PROJECT FILE REPORT ADDENDUM

The Regional Municipality of York

Northeast Vaughan Water Servicing Project
Class Environmental Assessment Revision
to Project File

MARCH 2023

Figure 2-2: Proposed Location of the PD8 Pumping Station (Block 34E)

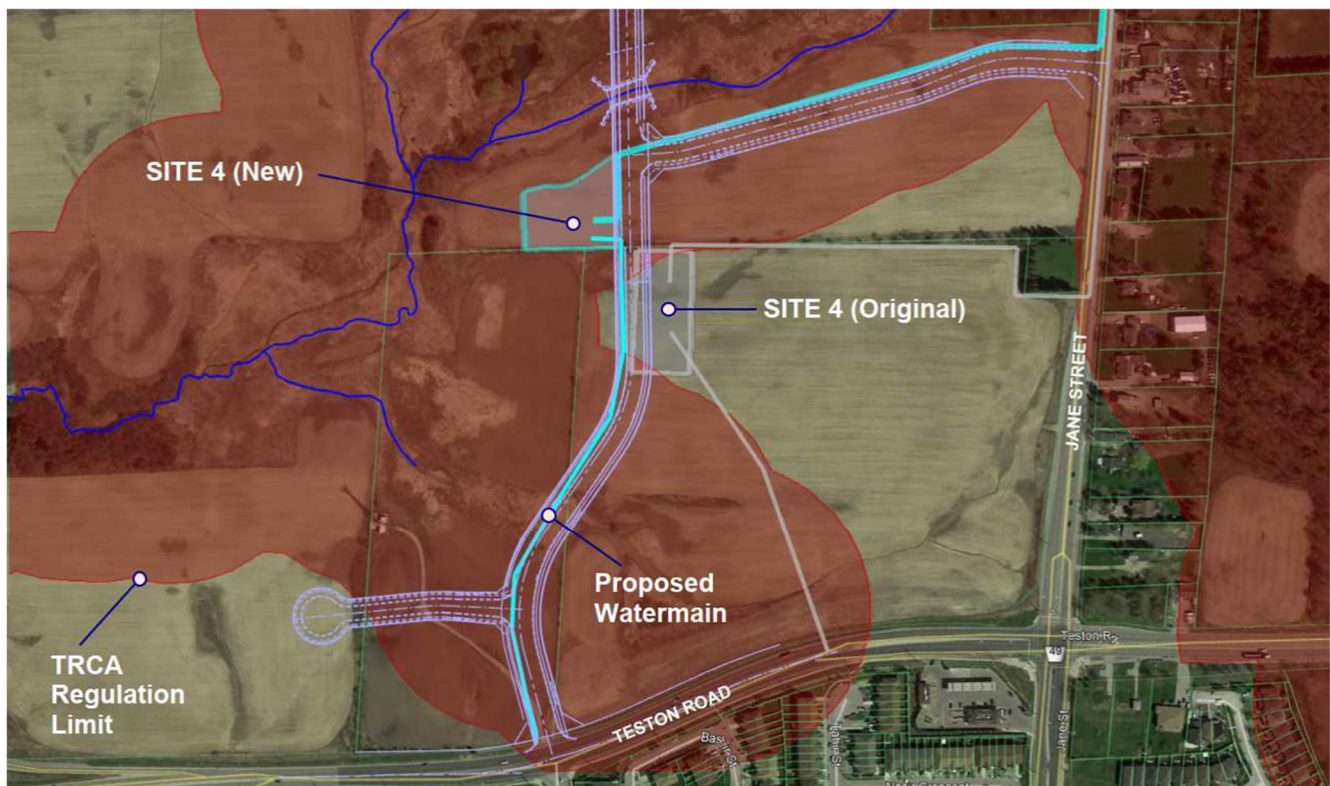
Following the MCEA Study and during property acquisition negotiations, the Landowners Group, representing the property owners of Block 34E, identified a preferred alternative location for the PD8 Pumping Station approximately 100m (centre of site) northwest of Site 4. This new location will increase the available development potential for the property owners without significantly reducing the property purchased by York Region. The Block 34E Block Plan has been approved by the City of Vaughan showing the alternative location. Figure 2-2 illustrates the original Site 4 (as per the 2019 MCEA Study) and the proposed Site 4 (henceforth referred to as Site 4 New).

The Site 4 New location falls within TRCA Regulated Area. The Landowners Group have previously presented the Block Plan to TRCA showing the Site 4 New location. Further discussions between the Region, Associated and TRCA during November 2020, confirmed TRCA's general agreement in principle to the proposed location. Further opportunity for TRCA to comment will be realized through the various permits and approval processes including this

MCEA Addendum, TRCA Application for Development - Interference with Wetlands and Alterations to Shorelines and Watercourses, and Site Plan Approval. The proposed site does not encroach into the mapped floodplain and is outside of a buffer from the natural features that was agreed between TRCA and the Block Developer.

Based on the conceptual PD8 Pumping Station layout, the alternative site will accommodate the pumping station, driveway, parking spaces and standby generator and not encroach on the watercourse buffer area within TRCA regulated lands. Relocation of the PD8 Pumping Station site, will also require changing the watermain pipe alignment to and from the pumping station. Access to the site will be via a driveway off the new spine road within Block 34E. In the event the spine road is not constructed prior to the construction of the PD8 Pumping Station, an easement will be required for temporary construction access and a temporary access road from Jane Street.
